**PLANNED UNIT DEVELOPMENT  
STAFF REPORT****Date: December 15, 2022****DEVELOPMENT NAME**

Chart Industries

Planned Unit Development Approval to allow multiple buildings on a single building site.

SITE PLAN

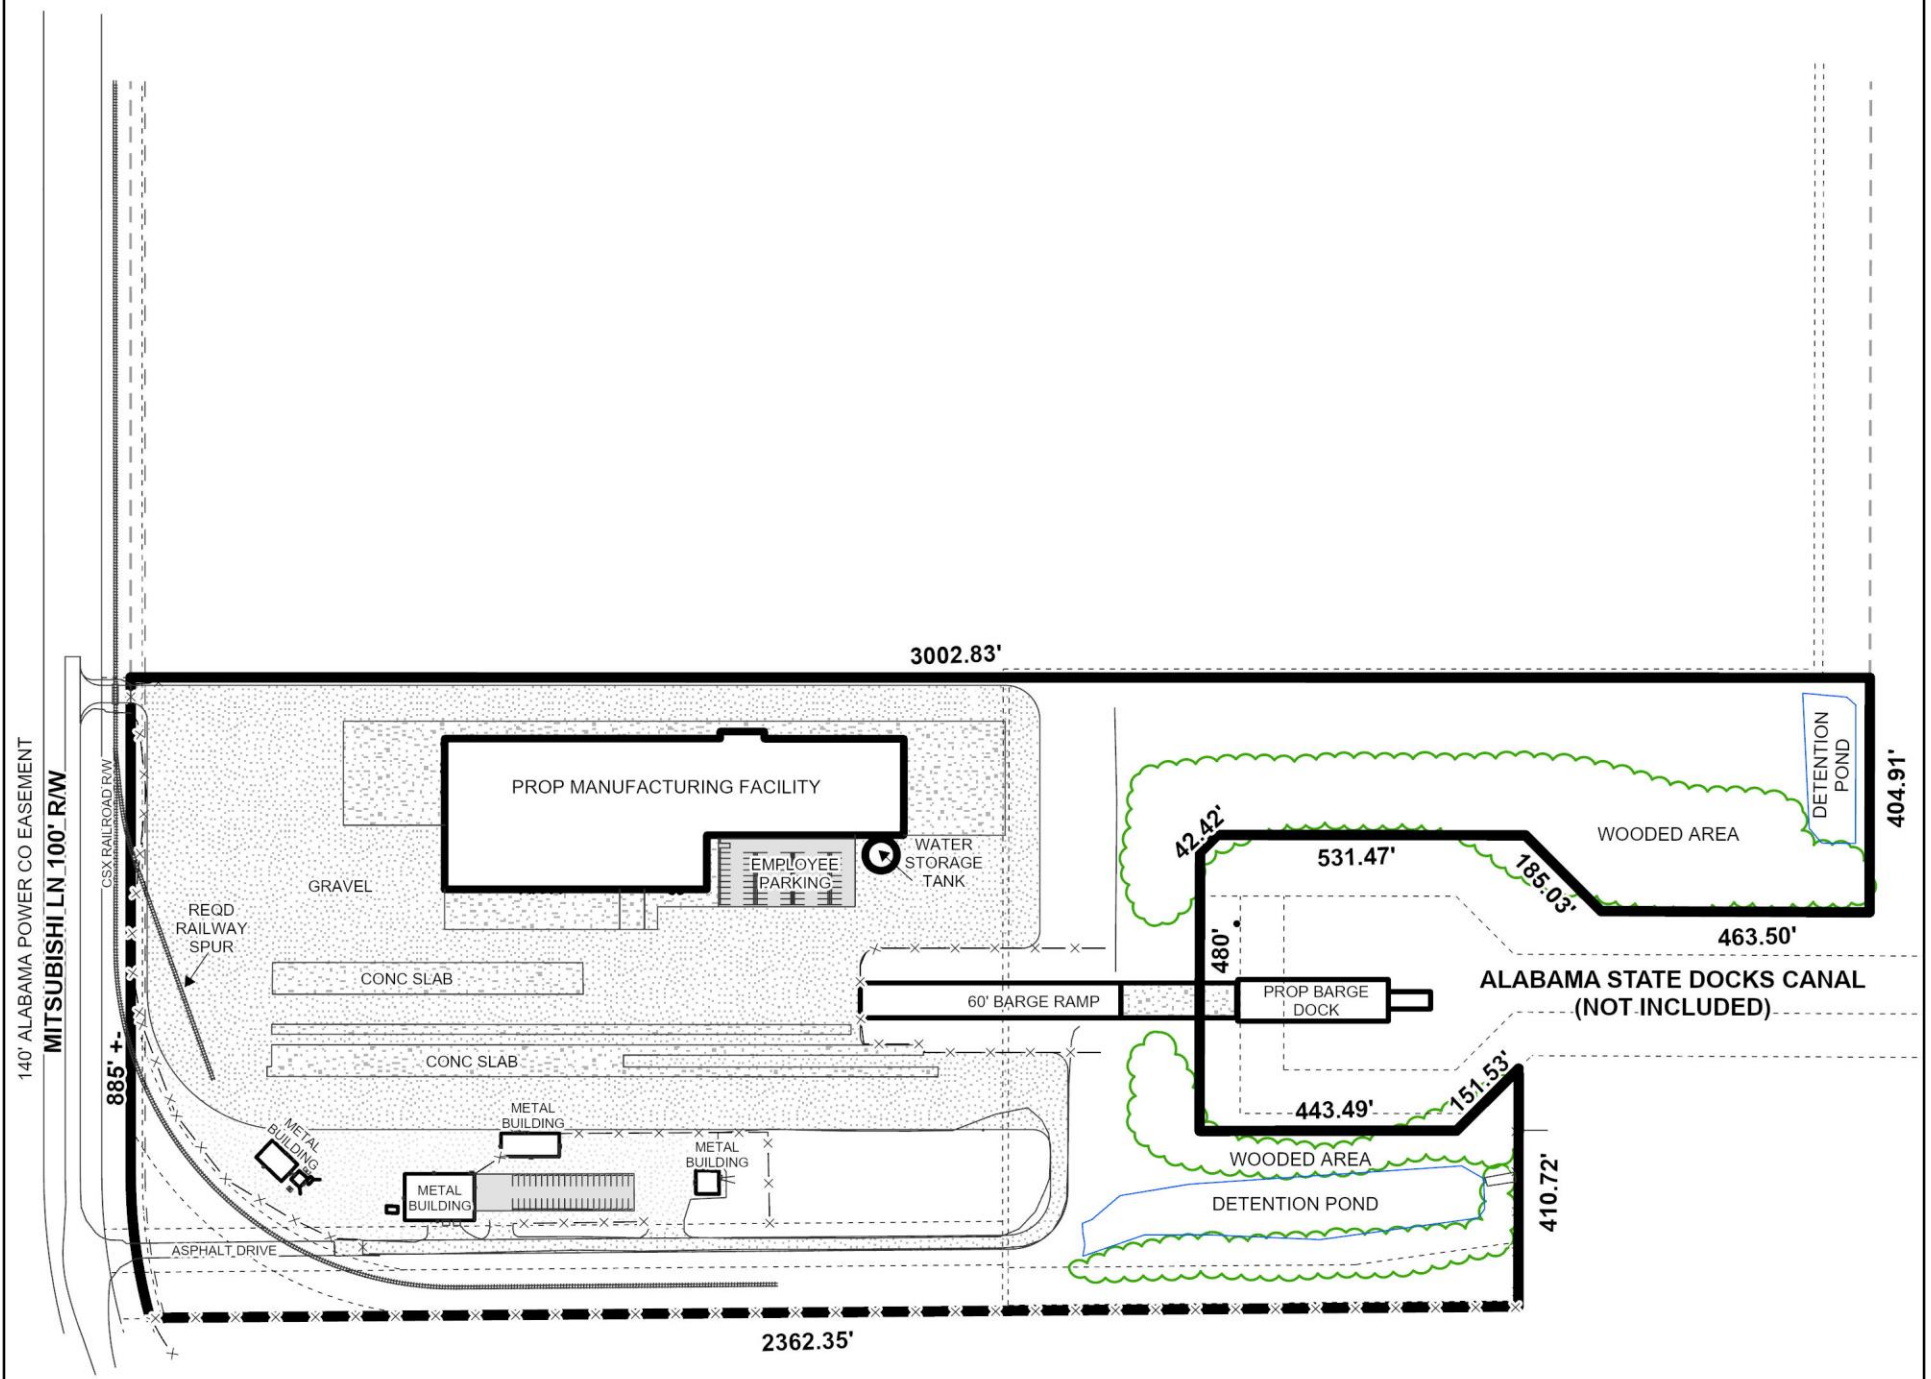
1. Retain NOTES #2 - #8, as shown on the OVERALL PUD PLAN, SHEET C201.
2. Correct the sheet number for the second sheet from C200 to C201.

The site is accessed by Mitsubishi Lane, which is labeled on the site plan as an easement. However, Mitsubishi Lane was actually deeded as right-of-way to Mobile County in 1974. Therefore, the site plan should be revised to indicate that Mitsubishi Lane is a public right-of-way with a 100-foot width. The site plan does not indicate the 25-foot minimum building setback line along Mitsubishi Lane, and should be revised to indicate such.

The site plan indicates numerous easements within the site for vehicular access, utilities, railroads and surrounding industries. Therefore, a note should be placed on the site plan stating that no structure is allowed in any easement without the approval of the easement holder.

As per the Traffic Engineering comments, the driveway number, size, location, and design are to be approved by Traffic Engineering and conform to AASHTO standards. Any required on-site parking, including ADA handicap spaces, should meet the minimum standards as defined in Section 64-6 of the City's Zoning Ordinance. Note #9 on the site plan should be revised as per the Traffic Engineering comments.

The site plan contains a table providing the landscaped area, but does not provide the specific calculations for the total area required and the total area provided, nor the frontage area required and provided. The site plan should be revised to provide such. Frontage trees only, are required in industrial zones; however, no frontage tree planting calculations are provided. The site plan should be revised to provide frontage tree planting calculations. As the City is looking closely at the spacing of heritage overstory tree plantings to provide a more favorable growth space, a spacing of at least 40' between trees is being considered as per the proposed Right Tree/Right Place concept. Therefore, the applicant should coordinate with staff on the location of heritage trees and the possibility of reducing the number of required trees with contributions to the Mobile Tree Commission for any reduction in required plantings

No dumpster is depicted on the site plan provided. If approved, the site plan should be revised to either depict a dumpster with a compliant enclosure and connection to sanitary sewer, or a note should be placed on the site plan stating that curbside pickup will be utilized. The site plan does not depict a sidewalk within the Mitsubishi Lane right-of-way. Therefore, the site plan should be revised to provide a sidewalk within the right-of-way, or a Sidewalk Waiver application should be submitted.

- 1) completion of the Subdivision process for Standard Concrete Products Inc Subdivision, Resubdivision of Lots 1 & 2, prior to the issuance of permits for development;
- 2) revision of the legal description on the site plan to reflect the new legal description for the site;
- 3) retention of the site area table on the site plan in both square feet and acres, or the labeling of the site with the same information;
- 4) revision of the site plan to label Mitsubishi Lane as a public right-of-way with a 100-foot width;
- 5) revision of the site plan to indicate the 25-foot minimum building setback line along Mitsubishi Lane;

- 6) placement of a note on the site plan stating that no structure is allowed in any easement without the permission of the easement holder;
- 7) revision of the site plan to indicate compliance with Section 64-6.A.6 of the Zoning Ordinance pertaining to parking requirements for industrial, manufacturing, warehousing and distribution establishments;

- 8) placement of a note on the site plan stating that a compliant photometric site plan will be required at the time of permitting;
- 9) revision of the site plan to provide landscaping calculations indicating compliance with the total site area landscaping required and the frontage landscaping area required;

- 10) revision of the site plan to provide frontage tree planting compliance, to be coordinated with staff on the location of heritage trees and the possibility of reducing the number of required trees with contributions to the Mobile Tree Commission for any reduction in required plantings;

- 11) revision of the site plan to either depict a dumpster with a compliant enclosure and connection to sanitary sewer, or the placement of a note on the site plan stating that curbside pickup will be utilized;

- 12) revision of the site plan to provide a sidewalk within the Mitsubishi Lane right-of-way, or the submittal and approval of a Sidewalk Waiver application;

- 13) compliance with Engineering comments: *(1. Retain NOTES #2 - #8, as shown on the OVERALL PUD PLAN, SHEET C201. 2. Correct the sheet number for the second sheet from C200 to C201.);*

- 14) revision of Note #9 on the site plan as per the Traffic Engineering comments: *(Driveway number, size, location, and design to be approved by Traffic Engineering and conform to AASHTO standards. Any required on-site parking, including ADA handicap spaces, should meet the minimum standards as defined in Section 64-6 of the City's Zoning Ordinance.);*
